Review of Groundwater Assessment of EIS for McPhillamys Gold Project (SSD-9505)

Re: McPhillamys Gold Project - response to expert review of the EIS groundwater assessment

**Re: McPhillamys Gold Project (SSD-9505) – response to expert review of the Amendment Report
Groundwater Assessment Addendum**

Figure 3.1 Components considered for assessing surface water take

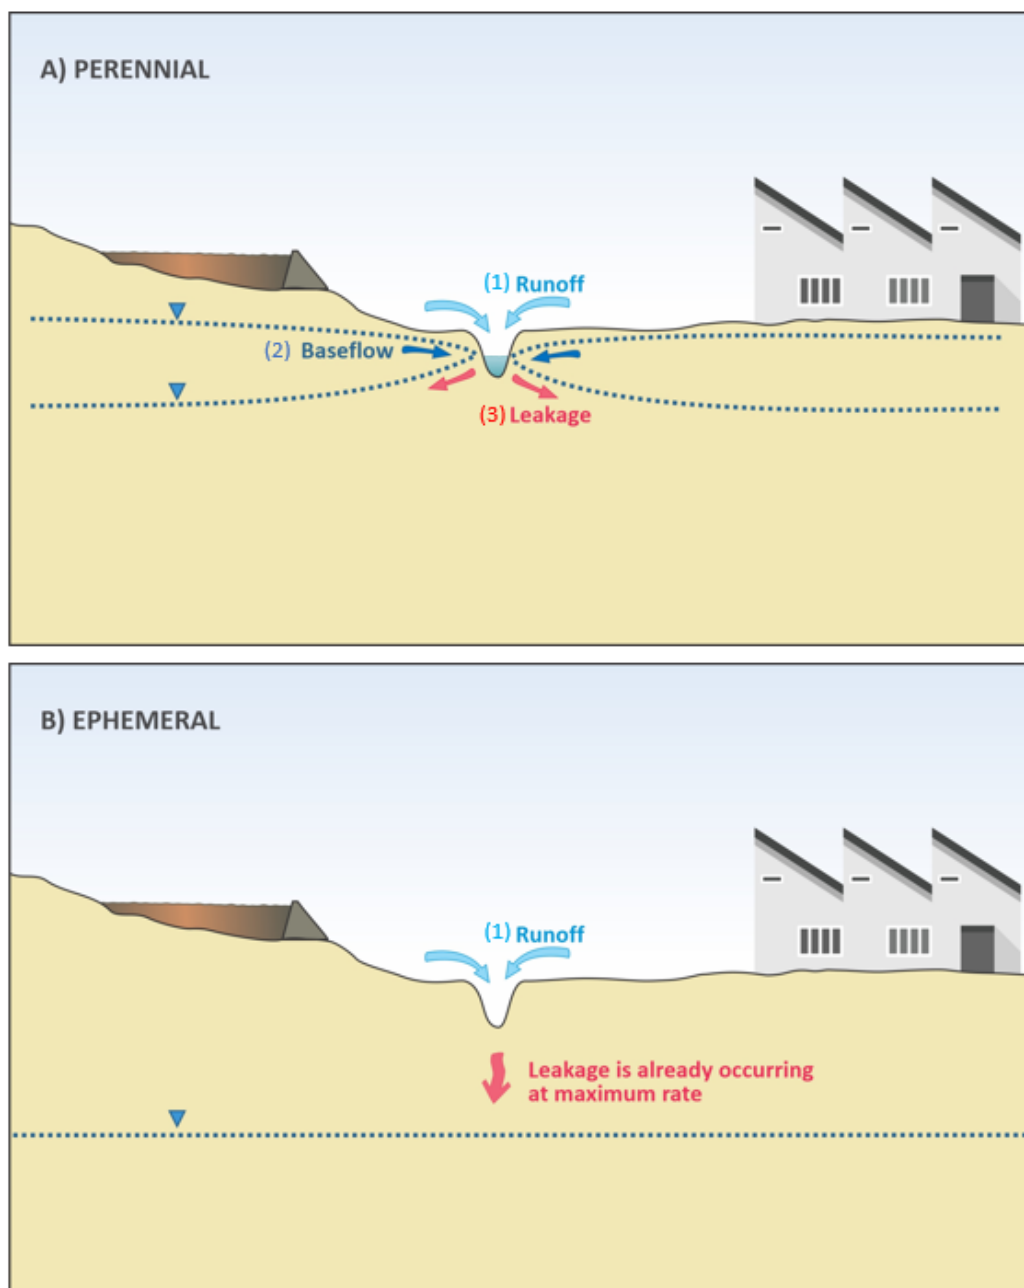
JBS&G provided the following comment:

Surface water ‘take’ has been assessed primarily as part of the Surface Water Assessment (Appendix J of the EIS) and summarised in Chapter 9 of the EIS. The points below summarise how it has been assessed:

Figure 3.1 provides a graphical representation of the components that were considered for surface water take.

Surface water take is estimated based on:

- (1) Change in surface water flow from reduced catchment
- (2) Reduction in baseflow
- (3) Increase in leakage

Figure 3.2 Conceptual diagram of perched highland springs

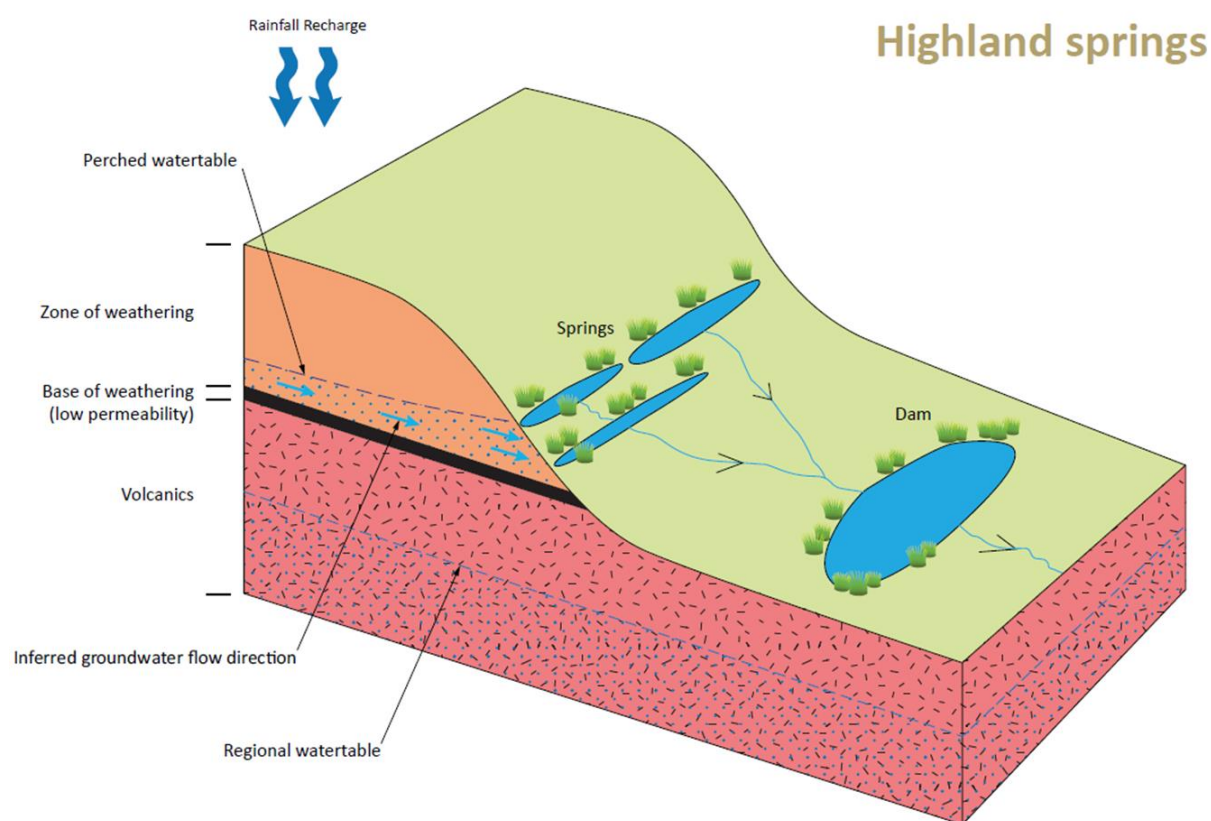
JBS&G provide the following comment:

A conceptual diagram is provided in Figure 3.2.

The groundwater model is a regional scale impact assessment model and is not designed to simulate small-scale local flow. The springs were not simulated in the groundwater model based on the conceptualisation and objective and scale of the groundwater model. EMM and Regis believe that revisions to the groundwater model on this aspect are not required.

Due to community focus and other submissions received on the EIS, EMM and Regis will provide further detail on the conceptual understanding and additional data collected since the EIS, as part of the Response to Submissions report.

Figure 3.3 Box and whisker plot of field-measured hydraulic conductivity

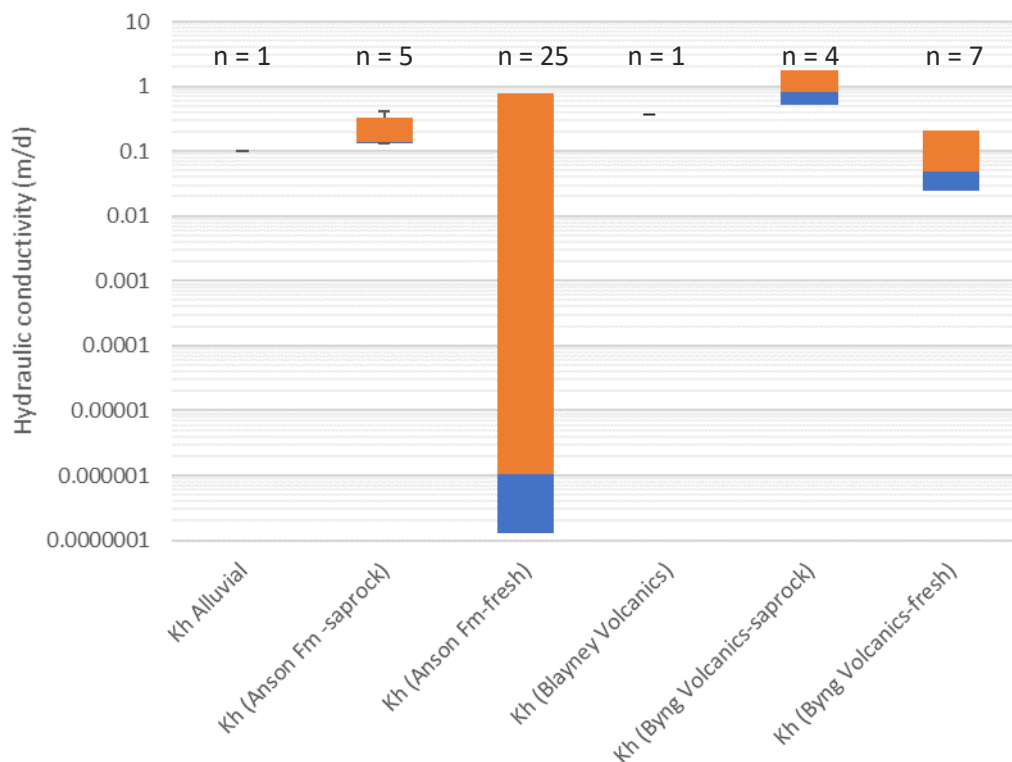
“JBS&G also considers that the current approach in the groundwater model, whereby there is an instantaneous transition (vertically) from Layer 1 (saprock) to Layer 2 through 9 (fresh rock), is inconsistent with the conceptual model presented in EMM (2019), namely that there is a gradually decreasing hydraulic conductivity with depth.”

Core samples have been analysed to estimate hydraulic conductivity. A Box and Whisker plot of the measured hydraulic conductivity data is presented in Figure 3.3, grouped by geological unit. The majority of tests have been performed on the Anson Formation due to the project being located in this unit. Field testing has been conducted over varying depths. The uncertainty analysis covered the range of measured hydraulic conductivities and literature values, by simulating fresh rock hydraulic conductivity over a range of five orders of magnitude (up to 1×10^{-3} m/day).

In order to respond to JBS&G's comment regarding the two-layer system, EMM have completed an additional uncertainty analysis scenario which included a more gradual vertical transition in hydraulic conductivity with depth. Information about this scenario is provided in Section 4. Increasing the hydraulic conductivity between saprock and fresh rock results in minimal change to calibration statistics and model predictions (when compared to the base case and reported uncertainty analysis). The results of the additional uncertainty analysis confirms that the modelling (including uncertainty analysis) completed as part of the Groundwater Assessment have adequately assessed the potential impacts of the project.

Figure 3.4 Relative composite sensitivity of model parameters against steady state SRMS

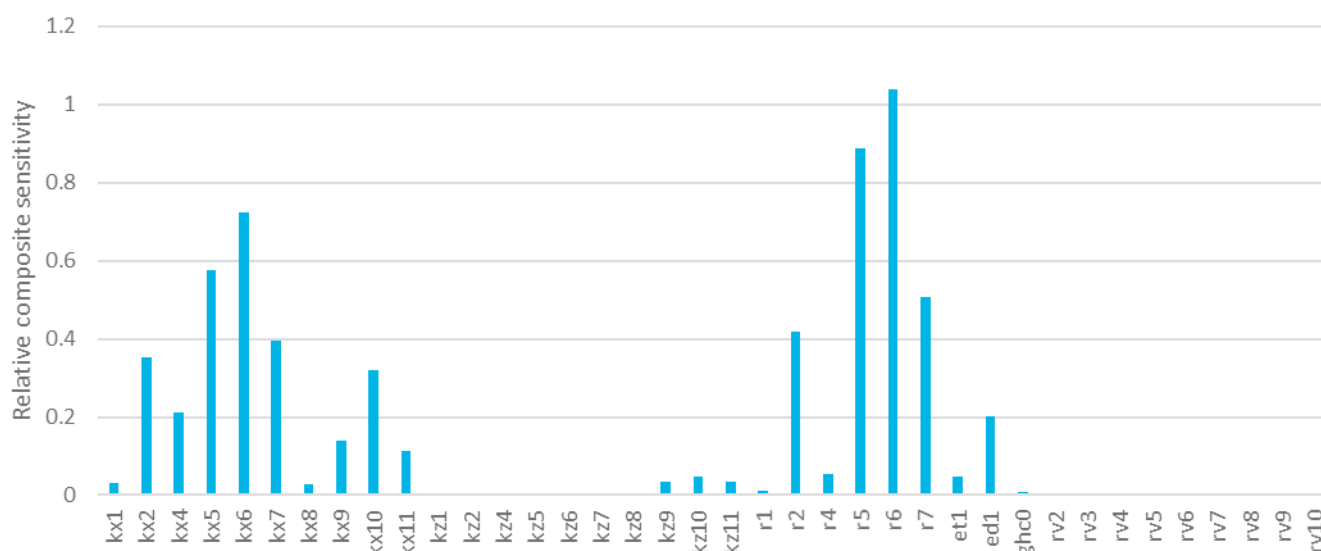
JBS&G provide the following comment:

Following the meeting on 2 December 2019, EMM performed a relative composite sensitivity (RCS) analysis on the base case model in order to quantify the sensitivity of the model calibration. The results are shown in Figure 3.4. The value of RCS is a unitless, scaled parameter corresponding to the sensitivity of the model calibration to changes in each parameter. Larger values mean that the model has a higher sensitivity to this parameter. The tested parameters are as follows:

Model layer 1 contains hydraulic conductivity parameter zones 1-7 (Table 2.1). As shown in Figure 3.4, the calibration is sensitive to horizontal hydraulic conductivity in this layer. The deeper layers representing fresh rock contain parameter zones 8-11 (Table 2.1). The calibration shows sensitivity to the parameter values in these zones higher than expected, with observable sensitivity to horizontal hydraulic conductivity and, to a lesser extent, vertical hydraulic conductivity. It is clear that despite the low number of measurements from the fresh rock, the properties of these units influence the overall groundwater conditions across the domain.

Parameters with greater RCS values indicate that the model calibration is sensitive to that parameter, but that the measurements have provided enough information to adequately constrain the calibration. Accordingly, the modeller can more easily determine reasonable upper and lower bounds for the more sensitive parameters. Noting the lower sensitivity of the model to fresh rock hydraulic conductivity, EMM applied a wider range of hydraulic conductivity in the sensitivity and uncertainty analyses for the deeper layers. In addition to this, the lack of calibration to storage parameters necessitated a wide range of values applied in the uncertainty analysis.

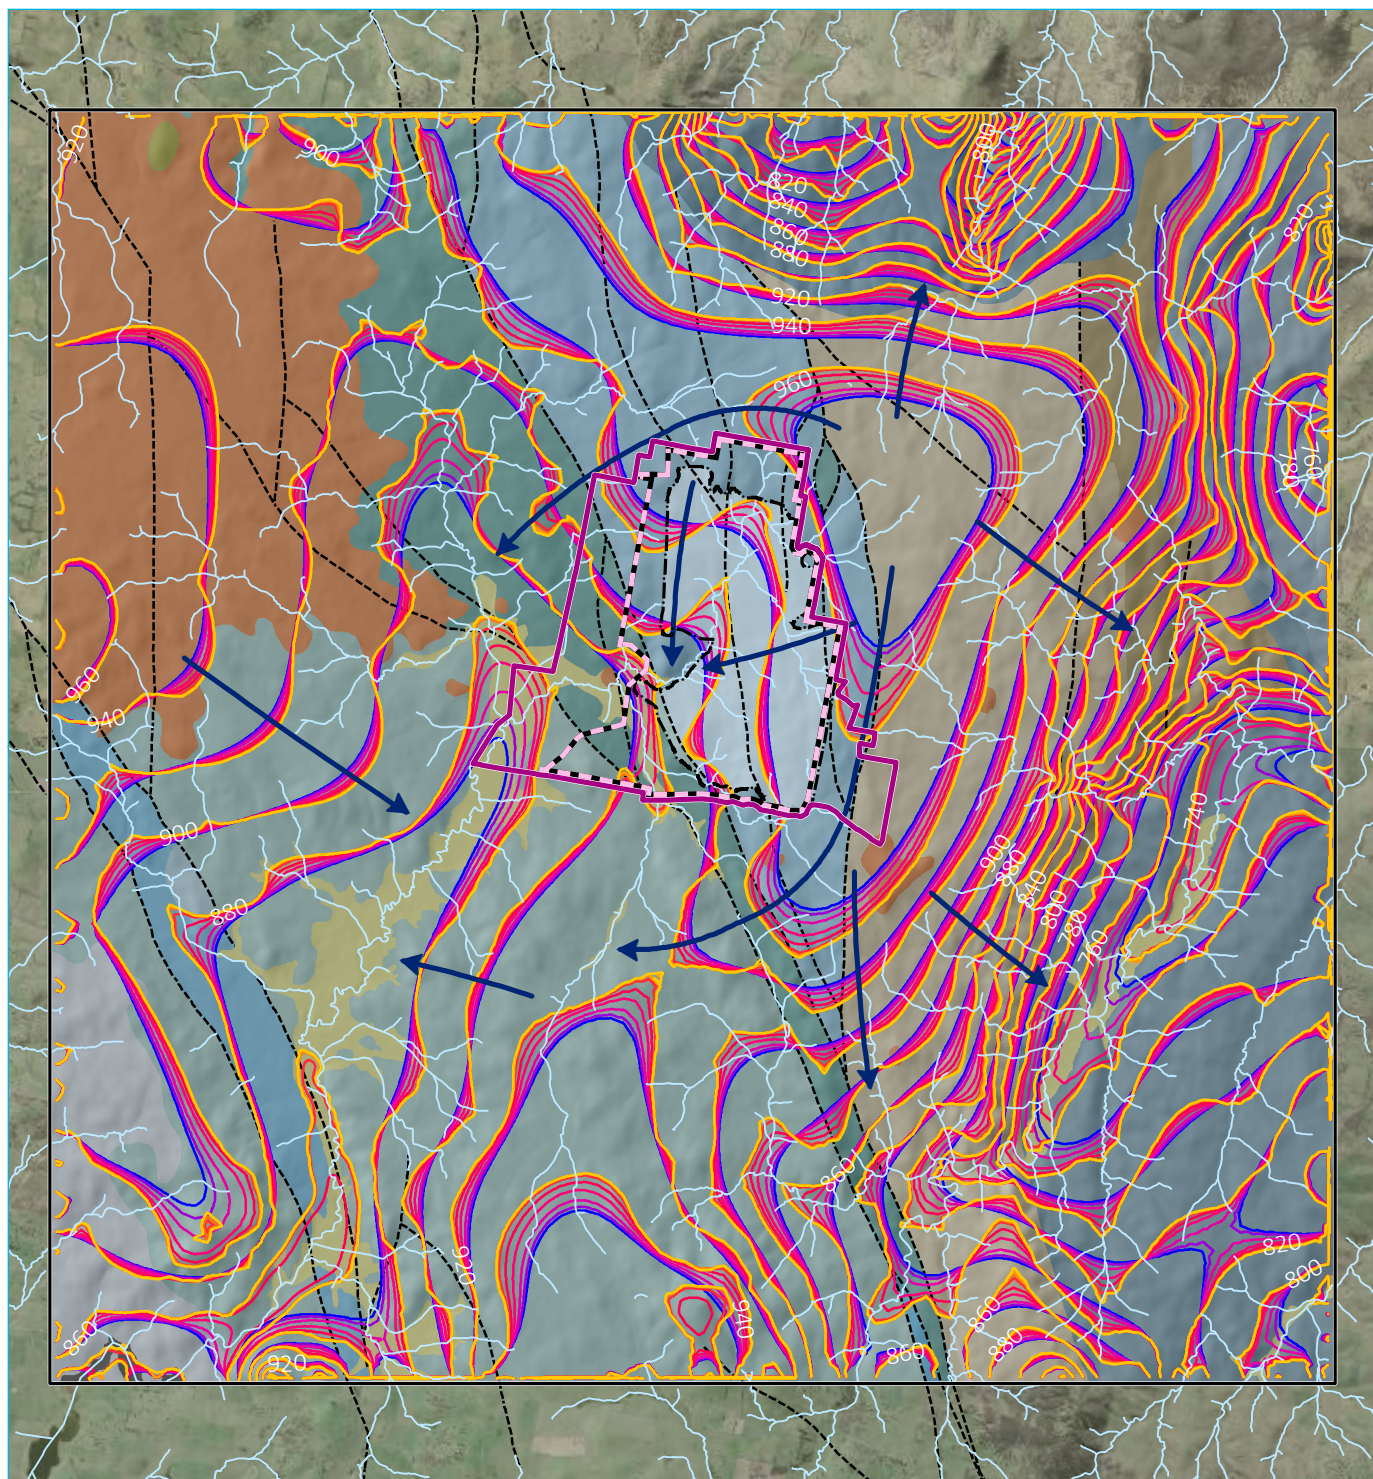
JBS&G provide the following comment:

EMM conducted a model run with an extended transient calibration period to assess climate baseline variability. The model setup and results are described in detail in Section 4. In summary, the extended transient verification period, using monthly recharge and evapotranspiration from 1970 to mid-2018, result in a slightly greater response to climate stresses in the history match period. Transient calibration statistics from 2017 to 2018 improve slightly from 6.1% to 5.9%. Whilst the revised temporal setup improves the model response to climate variability, the improvements are minor and do not influence the model predictions. The

results also show that the heads in the groundwater model are stable when it changes from steady state to transient and there is no observable drift at observation points.
